Gunnedah Solar Farm

SSD 8658
Response to Submissions

29 June 2018

Figure 1-2 Updated Constraints Map

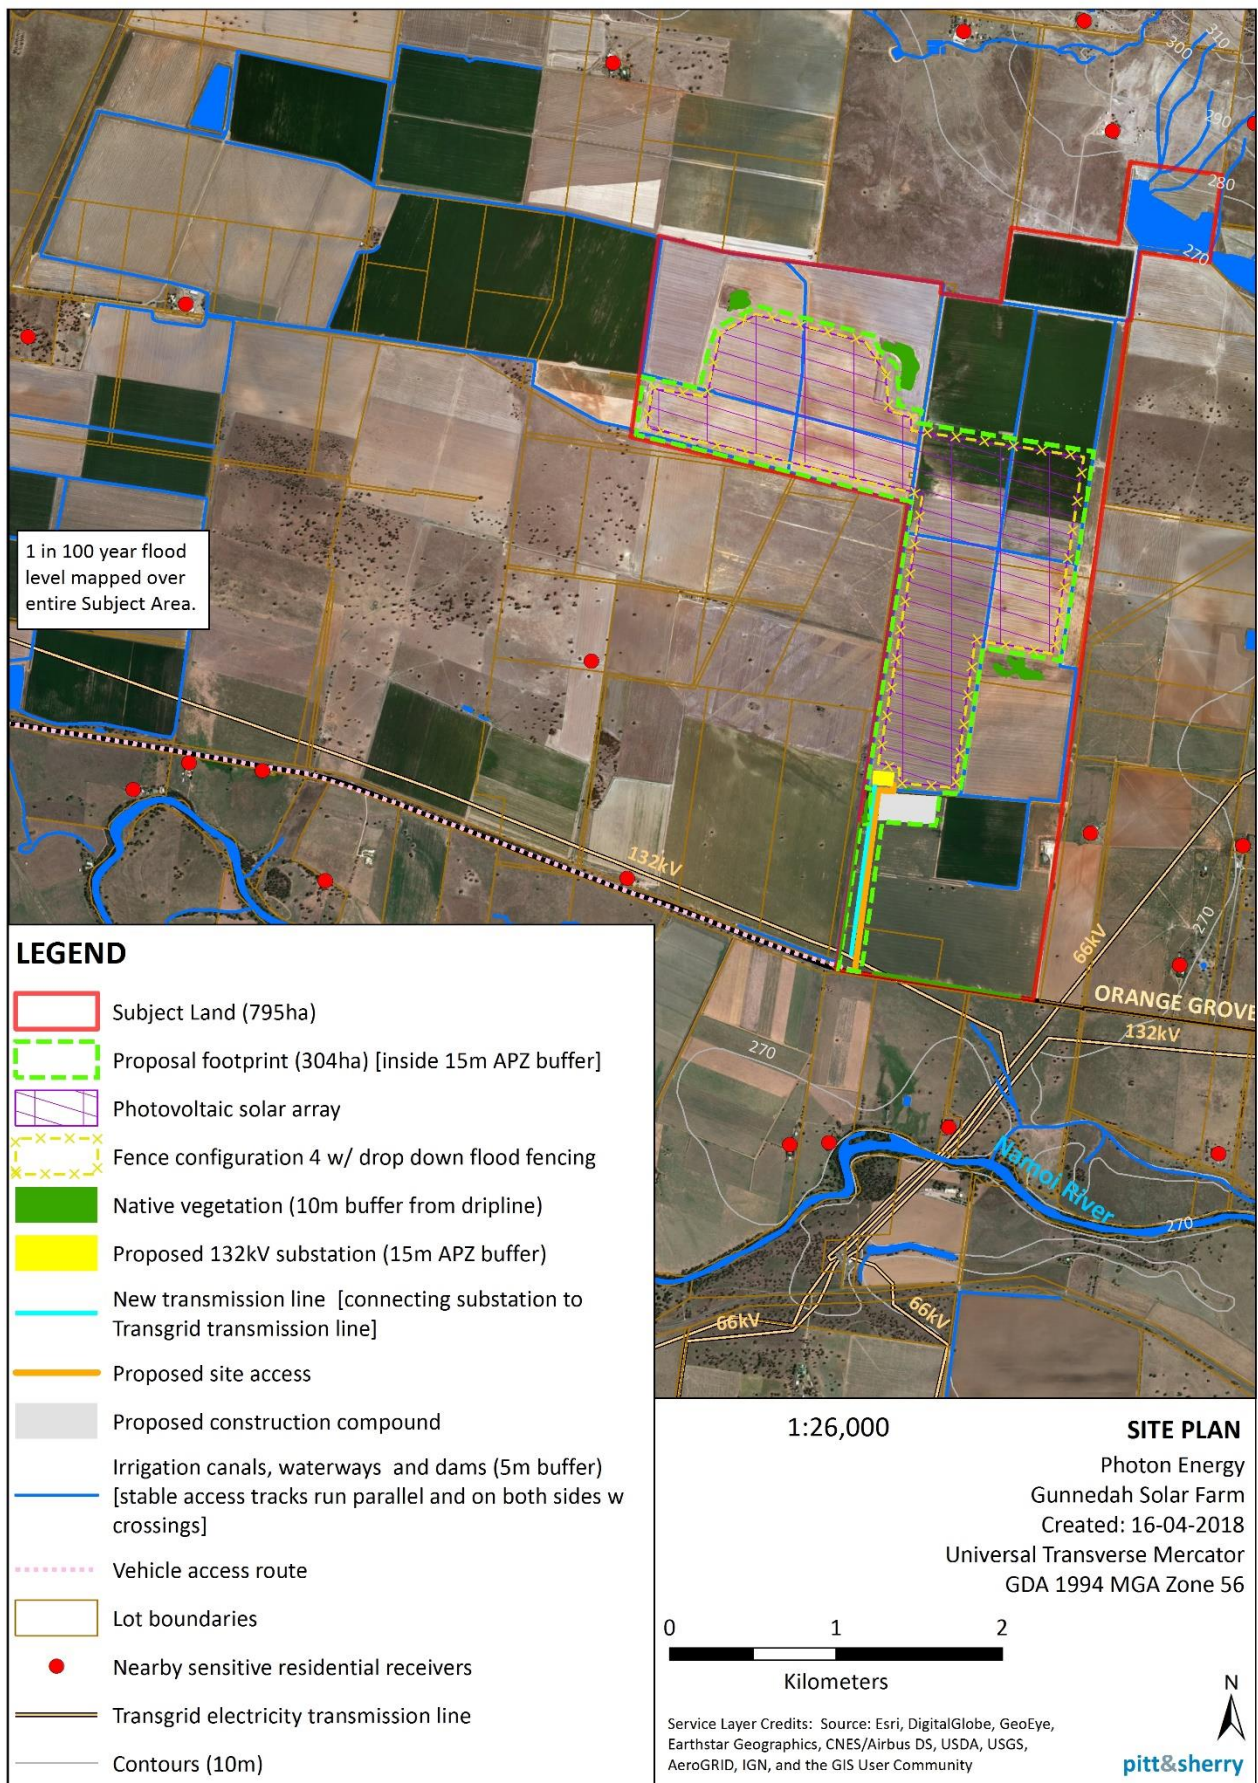
The locality of the GSF is shown in Figure 1-1. An updated site constraints map, as requested by Gunnedah Shire Council is shown in Figure 1-2.

Figure 3-1 Proposed fence design as Fence Configuration 4

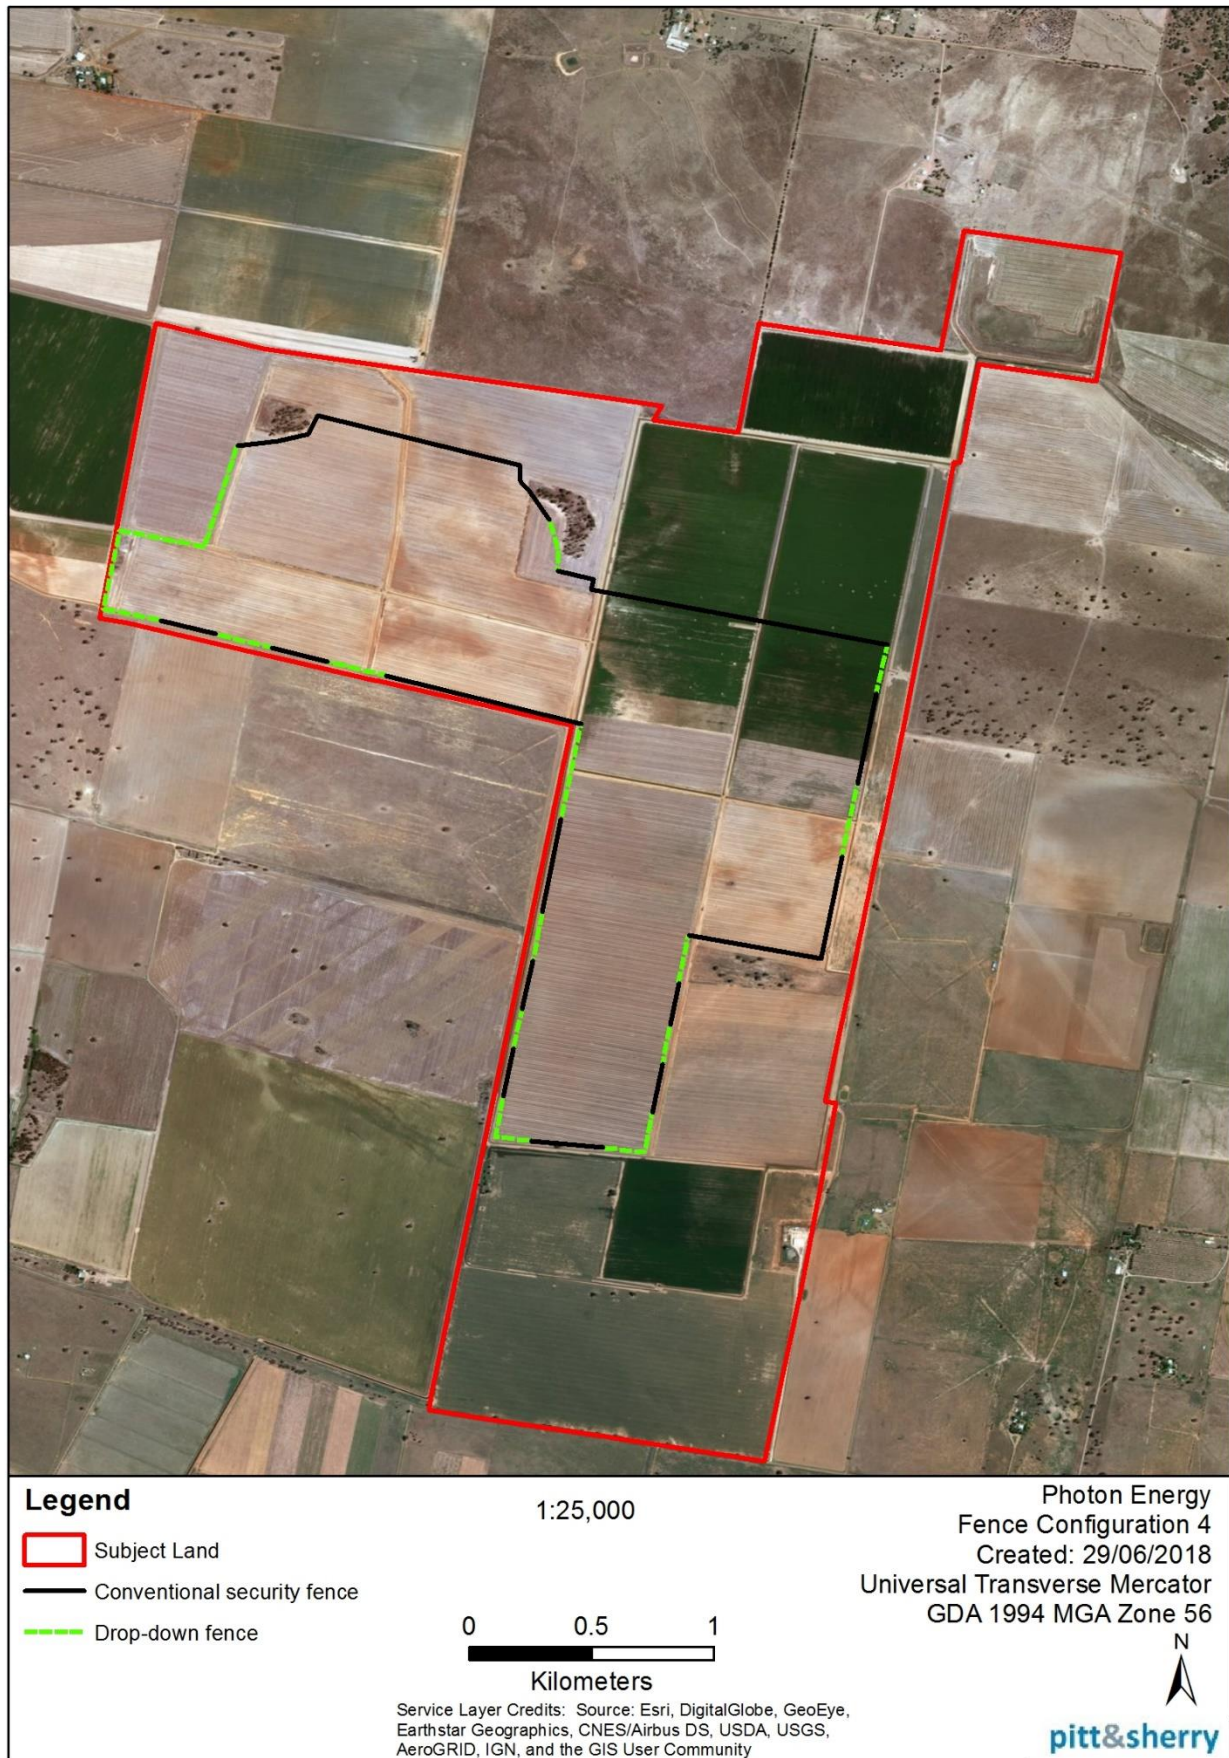
Aspect	Number of submissions	Detail of issue	GSF Response
Flooding: 48			
	46	Inappropriate location of solar farm in a floodplain / floodway. Concern over security fence and how it could block and redirect flows, worsening flood impacts to surrounding properties. Specific concerns relate to the effects of increasing flood depths and velocities, duration of flood and redirecting flood waters, damage caused by the washed away security fence. Potential impacts of concern include damage to fences, houses, pastures, farming operations, access restrictions, public safety, emergency services, erosion and sedimentation	<p>GSF recognises and accepts the concerns of the community in relation to potential flood impacts. To address this additional flood modelling has been undertaken using new terrain data and updated hydrology assumptions, and is detailed in the Updated Flood Impact Assessment (refer Appendix C).</p> <p>A new fence configuration (Fence Configuration 4) has been developed and modelled (refer Appendix C) and represents an alternative fencing design aimed at mitigating the blockage and redirection of floodwater, and the potential impacts of the Proposal on the surrounding landscape and residents during a flood event. Fence Configuration 4 incorporates drop down fencing in key areas. The model indicates that Fence Configuration 4 further reduces flooding impacts compared to the fence configuration presented in Appendix J of the EIS (Configuration 3), is compliant with the Carroll-Boggabri Flood Management Plan 2006 and would have negligible flood impacts on surrounding properties.</p> <p>In particular, the development would NOT:</p> <ul style="list-style-type: none"> • Redistribute peak flood flow by more than 5% on adjacent landholdings • Increase flood levels by more than 100mm on adjacent landholdings • Increase flow velocity by more than 50% for a range of flood scenarios including the relevant large design flood, unless Increases by more than 50% are in isolated areas • Increase flow velocity by more than 50% at the boundary • Increase drainage time by more than 24 hours of natural/existing drainage time. <p>The modelling indicates that the proposed solar farm would not cause appreciable impacts on surrounding properties due to increasing flood depths and velocities. Nonetheless, GSF recognises that modelling alone may not entirely address community concerns. GSF therefore commits to constructing a perimeter security fence that is designed to allow flood water into and through the development site during significant flood events, which will mitigate the impacts of potential fence blockage on flooding.</p>

A new fence configuration (referred to as Fence Configuration 4) has been developed and modelled as depicted in Figure 3-1, and further described in Appendix C. It represents an alternative fencing design aimed at minimising blockage and redirection of floodwater and the potential impacts of the Proposal on the surrounding landscape and residents during a flood event. Fence Configuration 4 incorporates drop down fencing in key areas. The model indicates that Fence Configuration 4 further reduces flooding impacts compared to the preferred fence configuration presented in Appendix J of the EIS (Configuration 3) and produces an entirely acceptable outcome that is compliant with the Carroll-Boggabri Flood Management Plan 2006 and have negligible flood impacts on surrounding properties.

GSF commits to construction of perimeter security fencing which is designed to allow flood water into and through the development site during significant flood events to minimise potential redirection of flood flows due to fence blockage. Design of the fencing shall seek to prevent offsite impacts in relation to flood levels and flood velocity, consistent with the complying works criteria in the Carroll to Boggabri Floodplain Management Plan 2006. The detailed design of the perimeter security fencing would be undertaken post consent and as part of construction certificate approval.
